COMMERCIAL AVENUE SANITARY SEWER RECONSTRUCTION

CITY PROJECT NO. 14921
CONTRACT NO. 9486

ADDENDUM #3: 9/3/2024

REVISION #2: 12/2/2024

14921	10/14/24	EAC	BY
PAST MARKUP REMOVAL, ATC FIBER	10/14/24	EAC	BY
REVISION	DATE	BY	BY
1	10/14/2024	2:18 PM	Scale: 1" = 40'
MARK	DESIGNED BY: EAC	DATE	DATE
14921	14921	9486	EC-3B

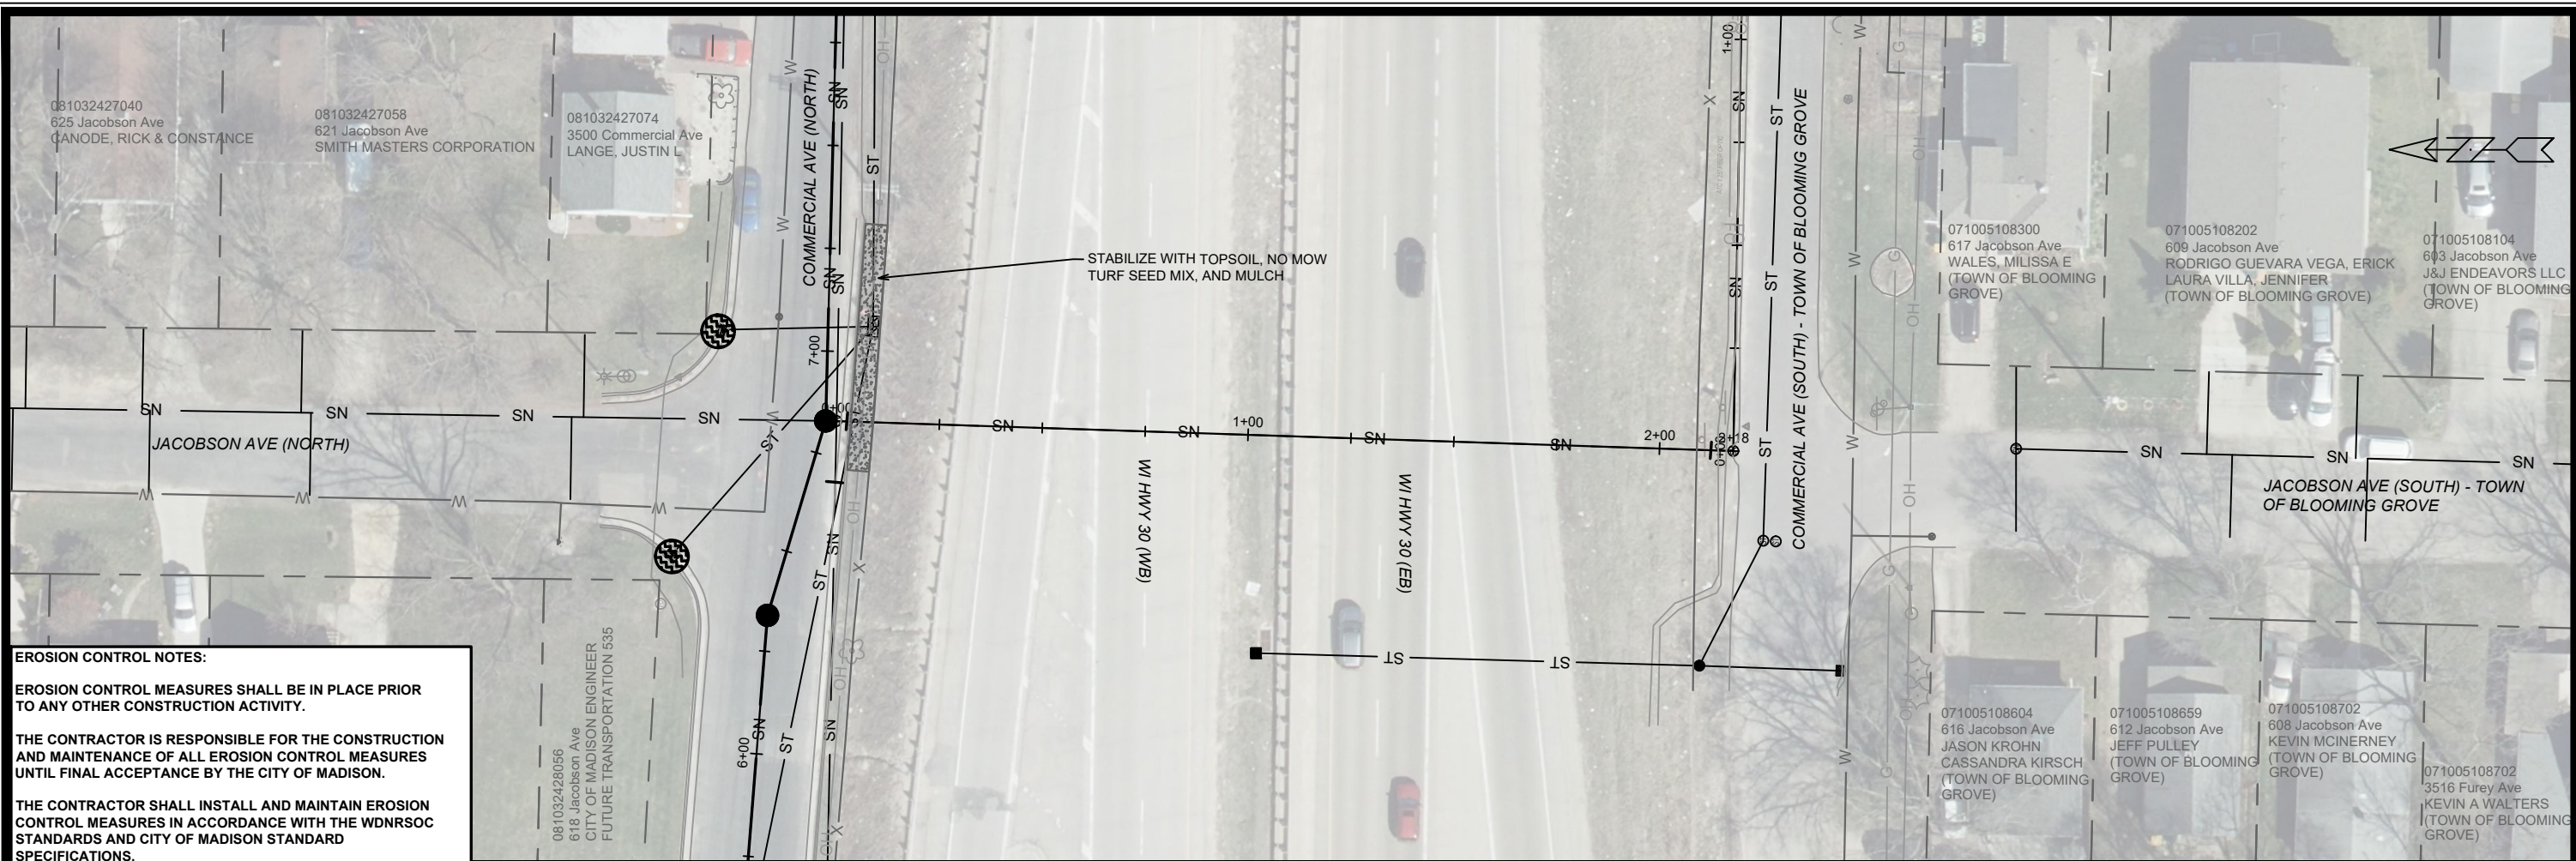
REVISION #1: 10/14/2024
 1. ADDENDUM #3 MARKUPS HIDDEN ON PLANS (ALL SHEETS)
 2. UNMARKED ATC FIBER ON COMMERCIAL AVE. (SOUTH) ADDED WITH ADDITIONAL ULOS (EC-3B & EC-5)

14921	10/14/24	EAC	BY
14921	10/14/24	REVISION	DATE
14921	10/14/2024	2:18 PM	Scale: 1" = 40'
14921	14921	9486	EC-5

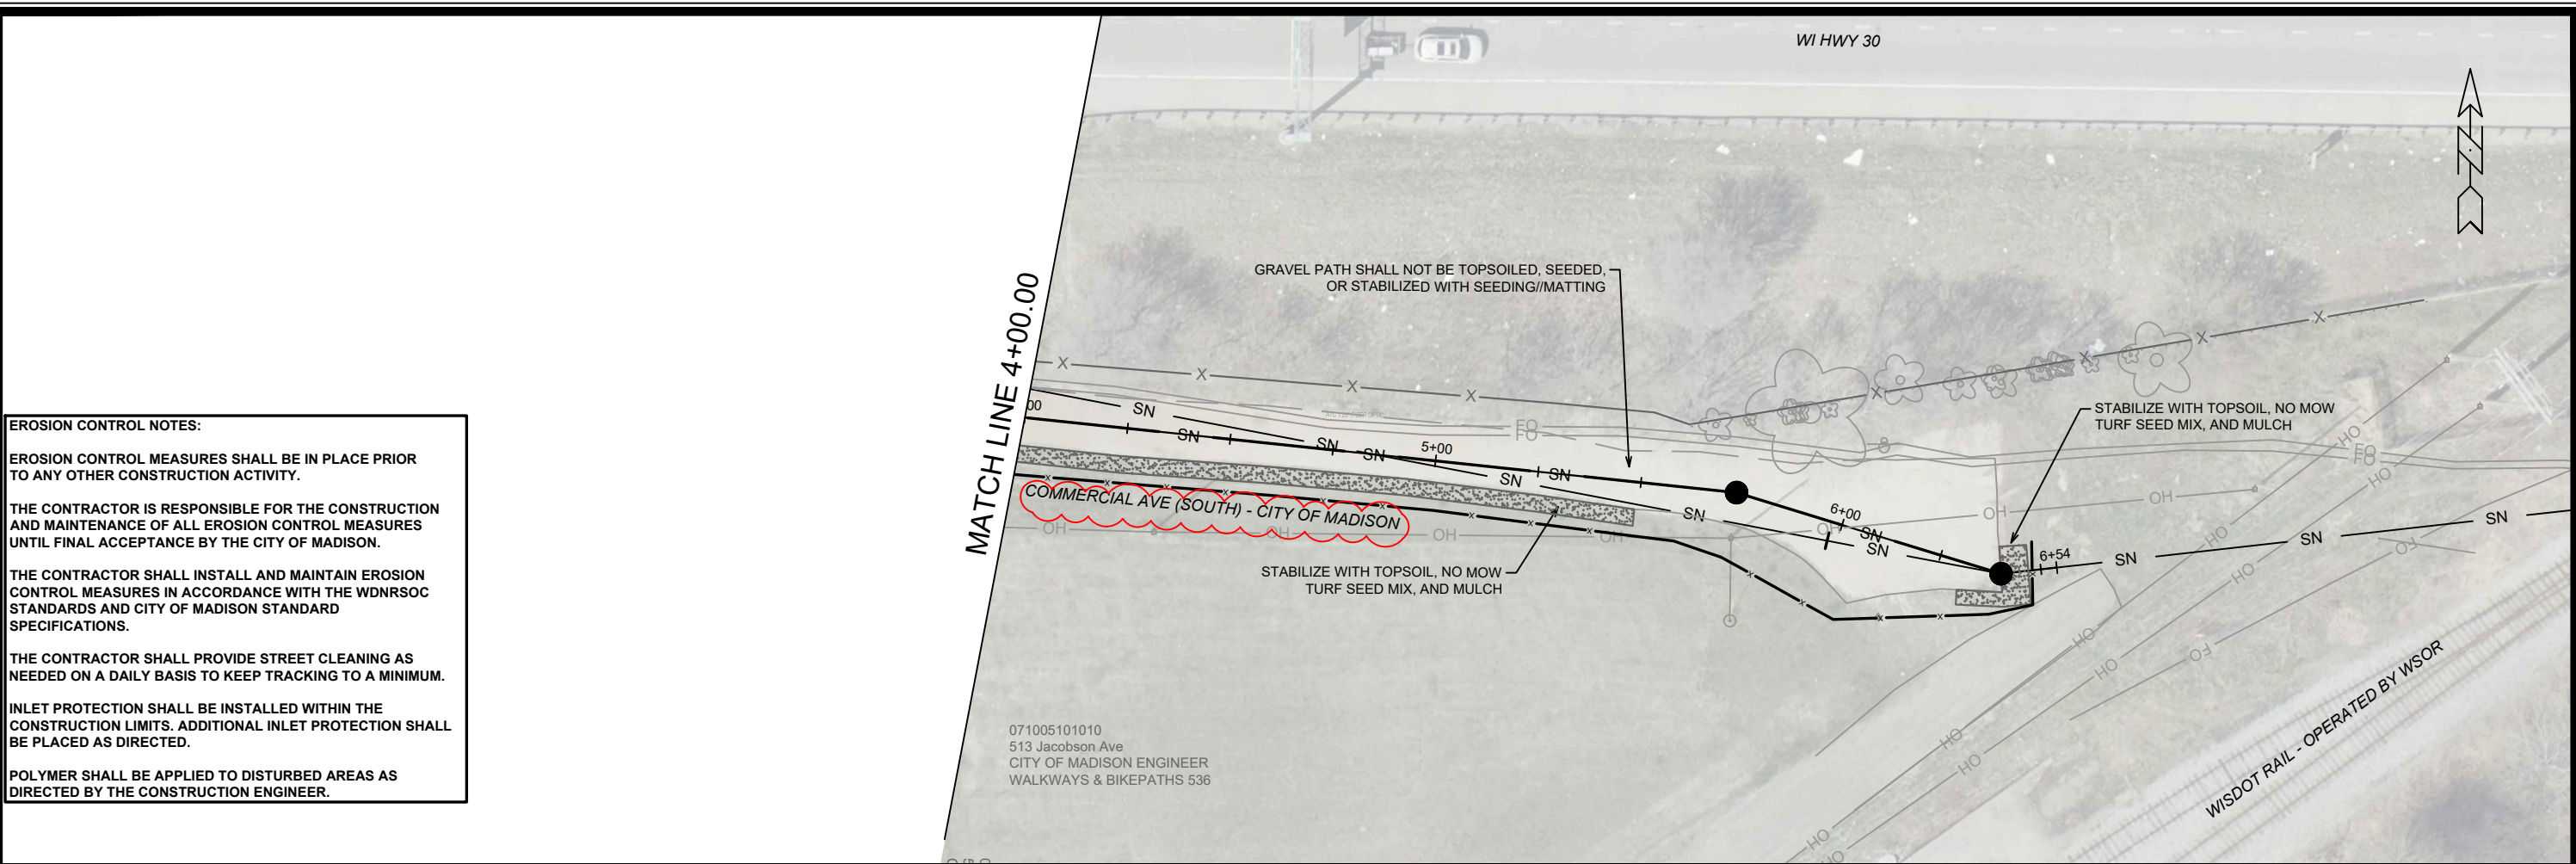
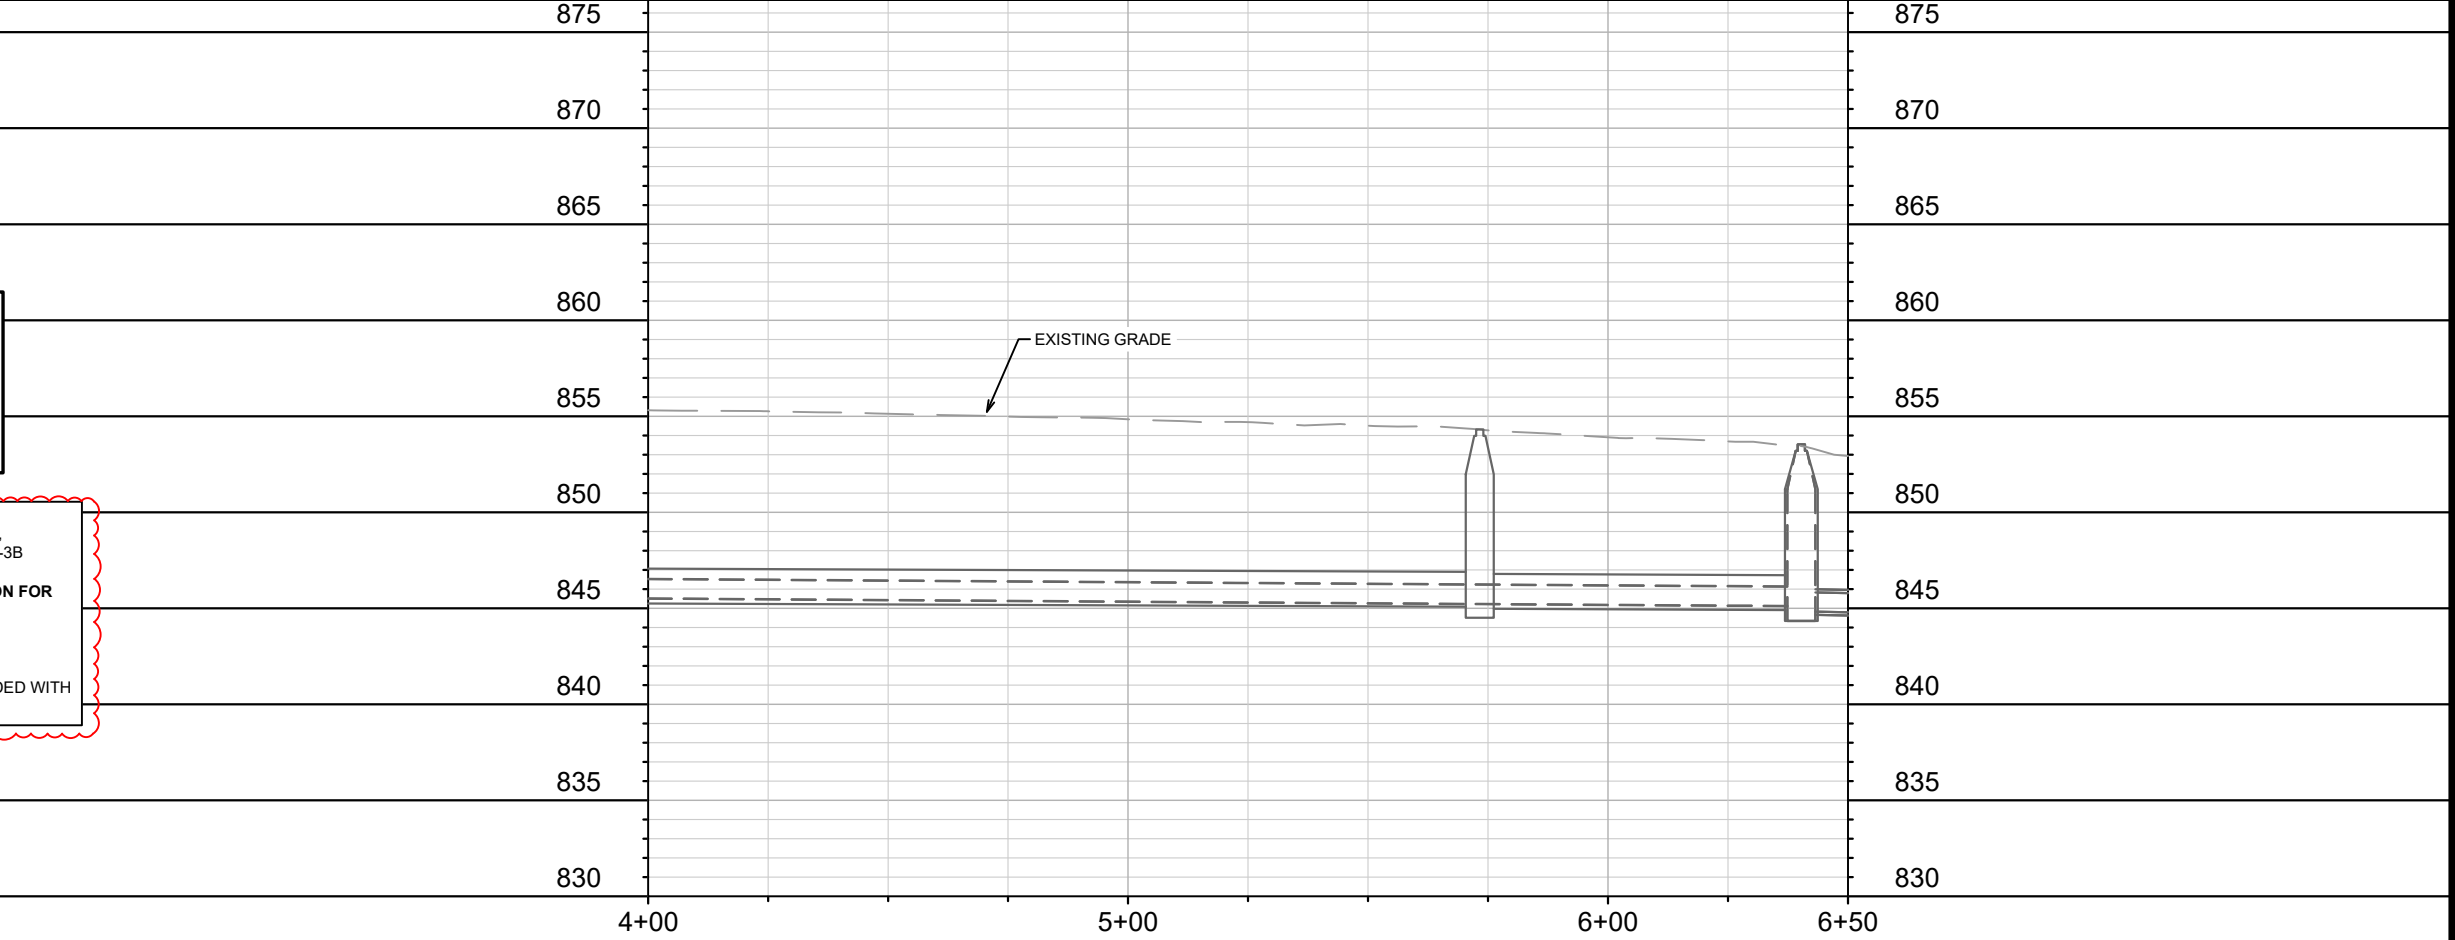
2. UNMARKED ATC FIBER ON COMMERCIAL AVE. (SOUTH) ADDED WITH ADDITIONAL ULOS (EC-3B & EC-5)

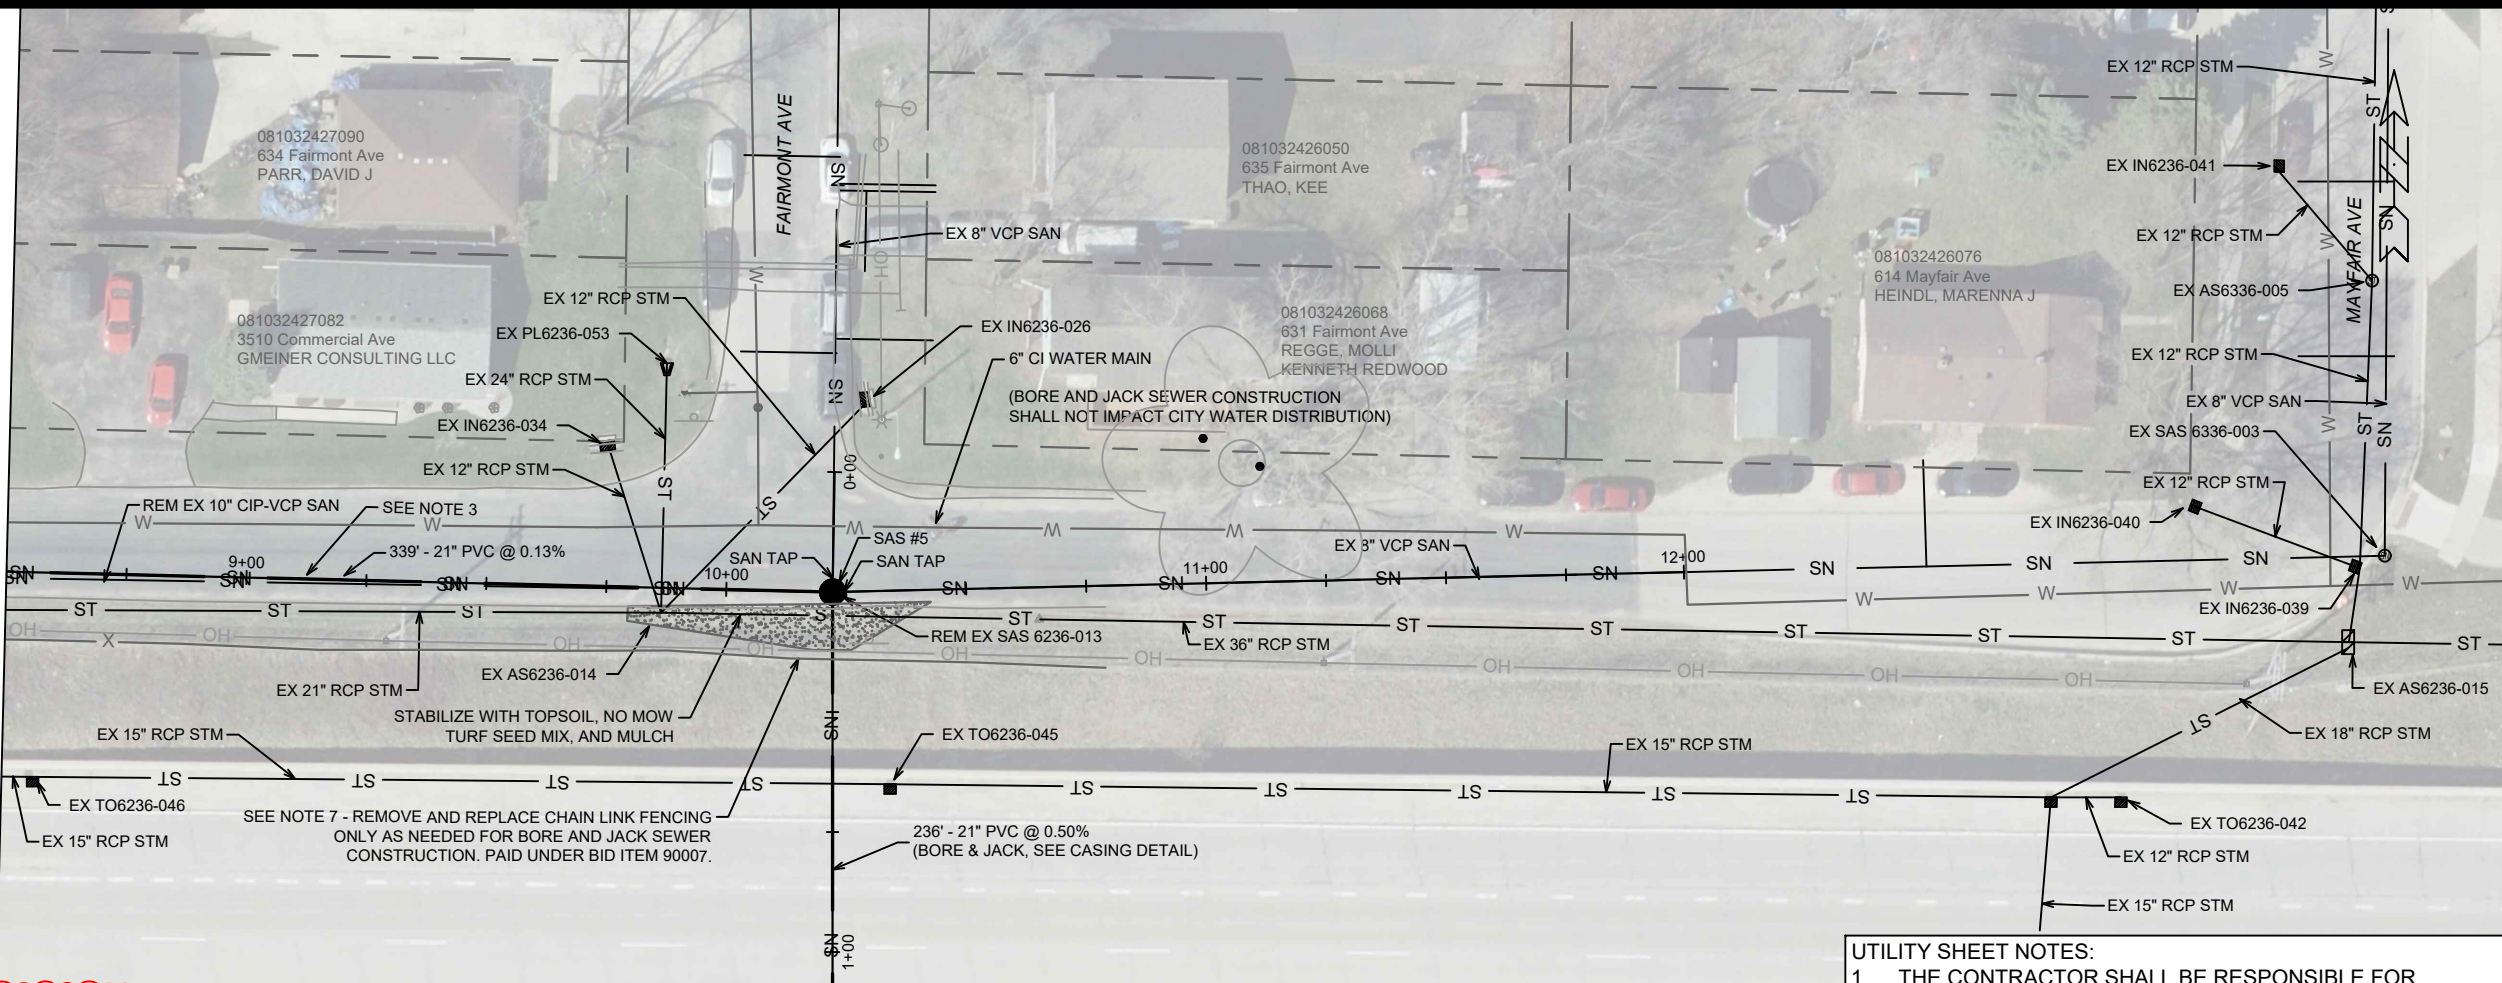
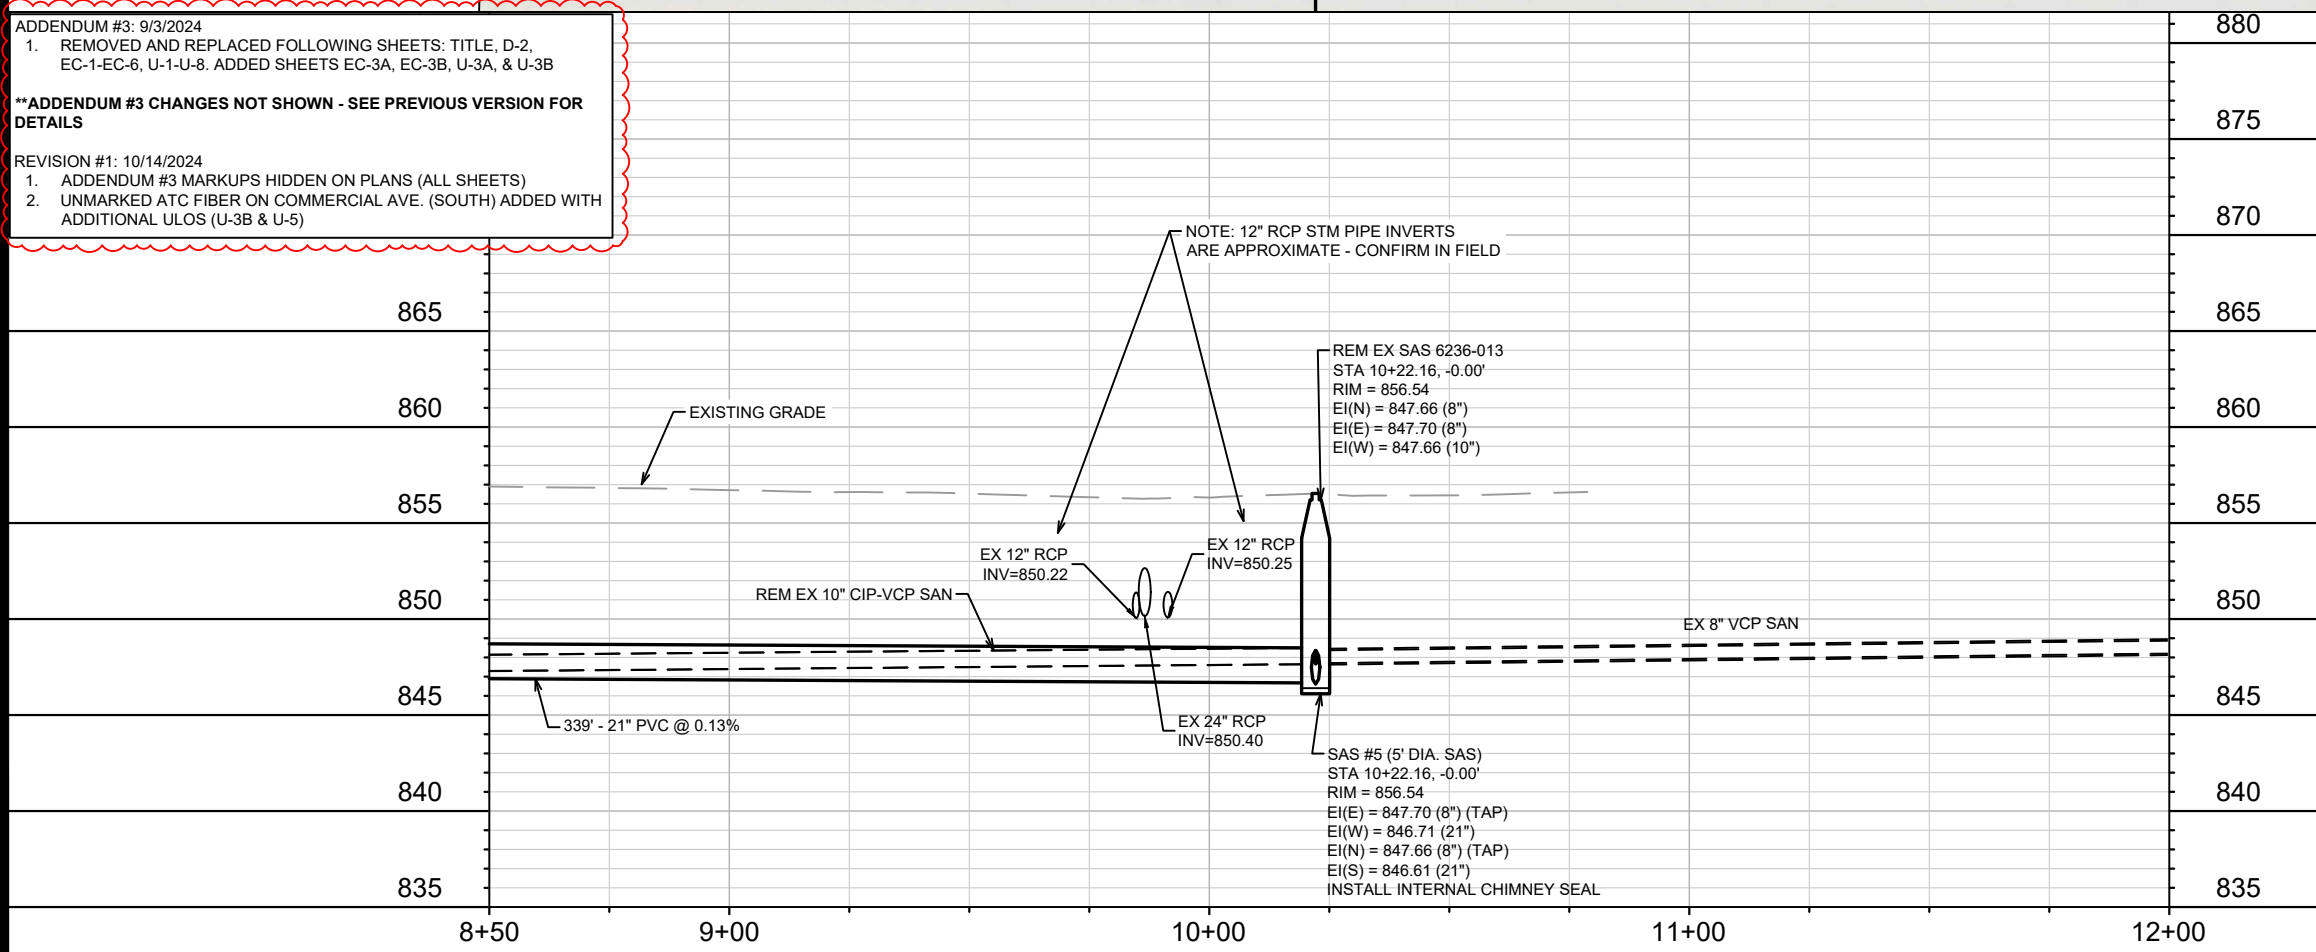
REVISION #2: 12/2/2024
 1. ULO DATA ADDED, DESIGN MODIFIED AS NEEDED (U-1, U-2, U-3B, & U-5)
 2. SAS #6 OUTSIDE DROP REMOVED, REPLACED WITH TAP (U-3 & U-4)
 3. SAS #4 TAP CORRECTED IN PROFILE (U-5)
